# REPORT TO COUNCIL

**Application:** HAP21-0001 **Owner:** Diane Duckett

Address: 1815 Abbott St Applicant: Diane Duckett

**Subject:** Heritage Alteration Permit Application - Major

#### 4.2 <u>Project Description</u>

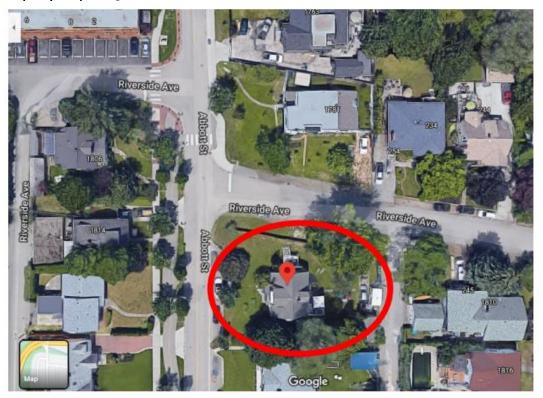
The proposal is to add a double garage, 2 new bedrooms and a bonus/transition area that will flow five steps down into the kitchen (existing). The original house has 2.5 storeys with a basement. The new addition will have 2 storeys, observing the Flood Construction Level rules. The main floor of the old part of the house contains living/dining areas, the kitchen, a bathroom and one bedroom that will become an office and transition to the second floor. The owner's goal is to create one larger home, relocating the secondary suite to grade level and making it partially handicap accessible. The improved home will comfortably accommodate family and guests, and, ultimately, a live-in caregiver and/or housekeeper if necessary. The existing upper floor suite will simply merge with the rest of the house and its small kitchen will be turned into a laundry/storage room.
